## Trim Cylinder End Cap and Anode Installation

Revised April 2016. This bulletin supersedes the previous bulletin number 2016-02 March 2015.

Interference between the anode mounting face and the end cap rod scraper may occur when installing anodes on end caps included in trim cylinder end cap kits 8M0110717 and 8M0115362.

**Bravo cylinder**

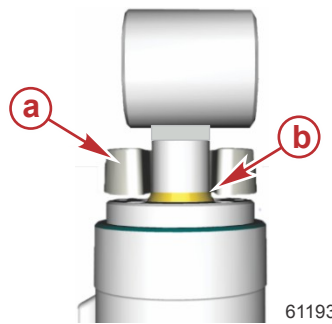
- a** - Anode
- b** - Interference area

Create a 0.13" x 45° tapered chamfer on the edge of the inside diameter of the trim cylinder anode mounting face to prevent interference when installing end caps included in end cap kits 8M0110717 and 8M0115362.

Bravo anode with chamfer

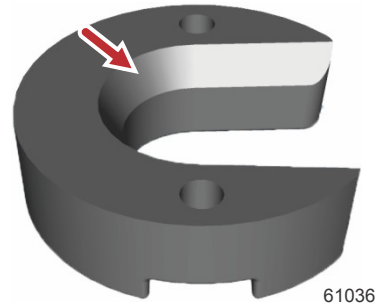
The anode modification described in this bulletin only applies to Alpha or Bravo anodes that do not have a chamfered edge when used with end caps included in end cap kits 8M0110717 and 8M0115362.

Alpha anode with chamfer

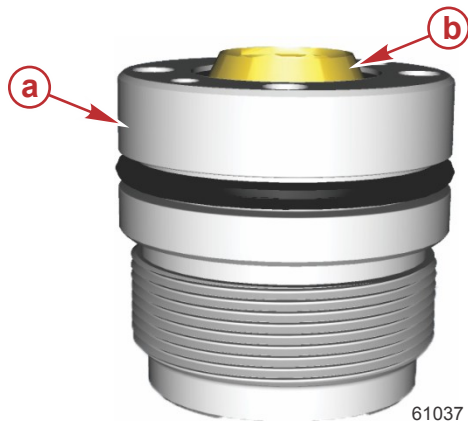
**NOTE:** End caps with protruding rod scrapers were also used during factory production on Bravo SeaCore transom assemblies starting with serial number 2A480244, and standard Bravo transom assemblies starting with serial number 2A485656. Perform the chamfering procedure described in this bulletin when replacing trim cylinder anodes on these units if the end cap has a protruding rod scraper.

- a - End cap
- b - Protruding rod scraper
